**IN THE DRAWINGS:**

Fig. 2

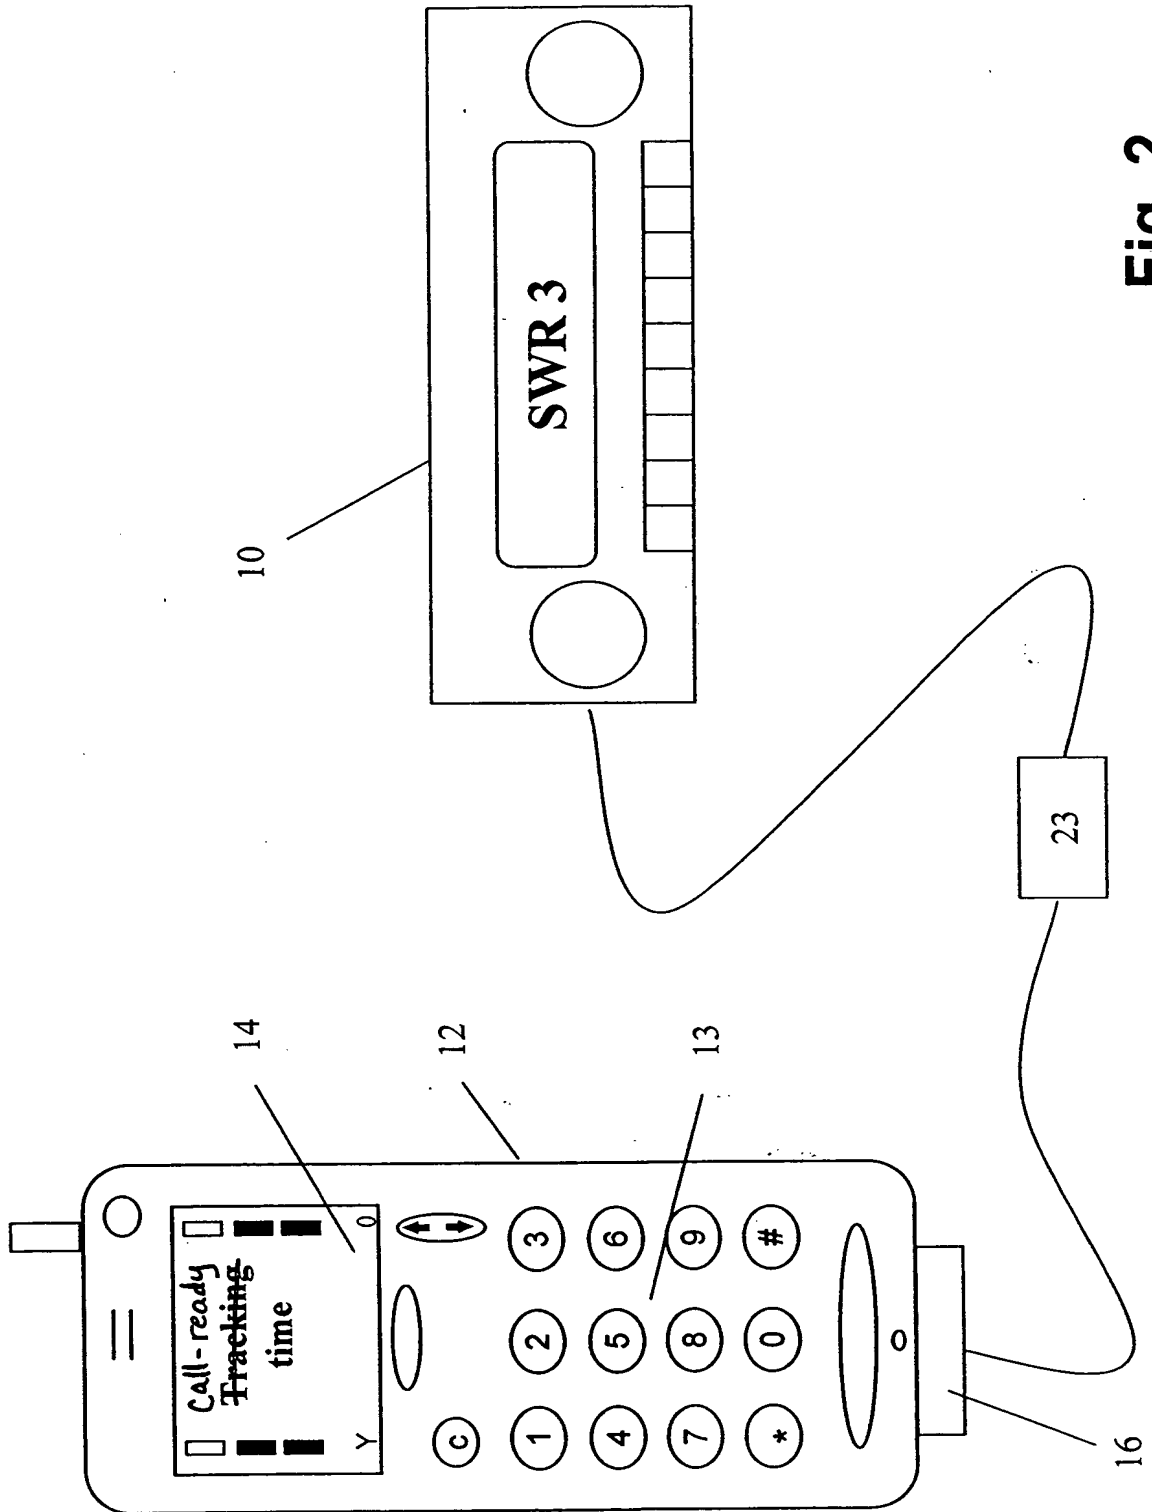
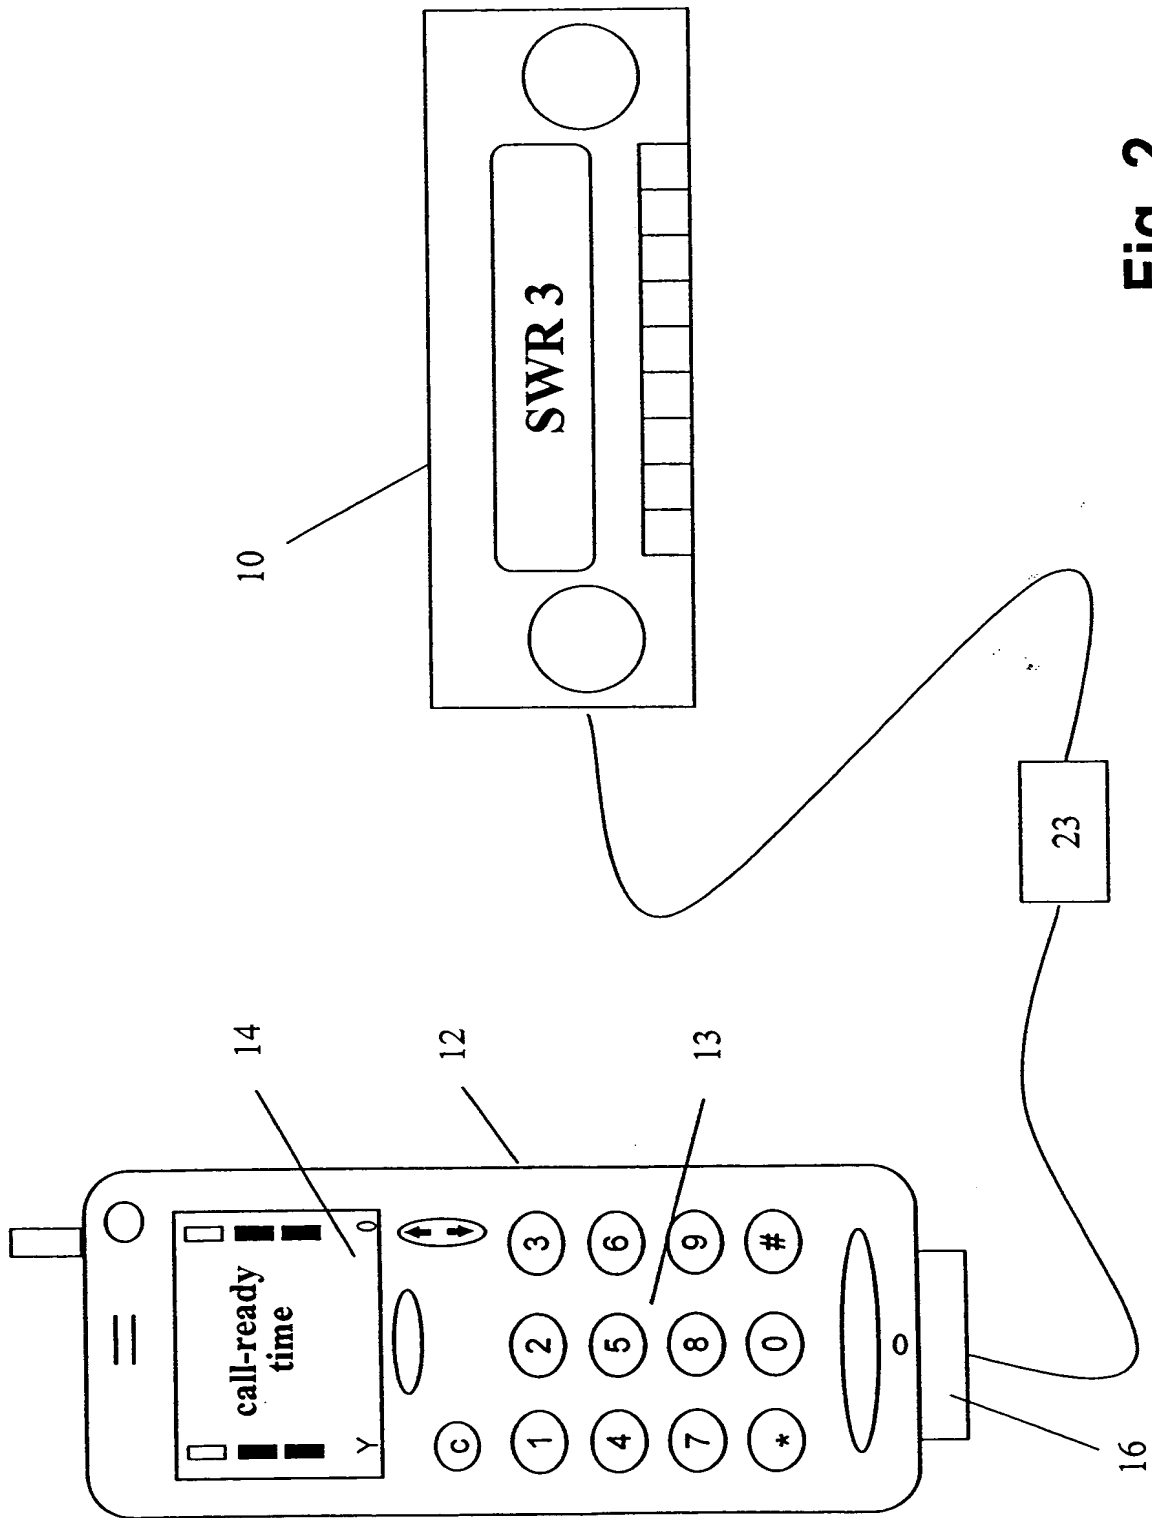
*Please amend Fig. 2 to have element 14 read "call-ready time" instead of "Tracking time" as shown on the attached drawing sheets.*
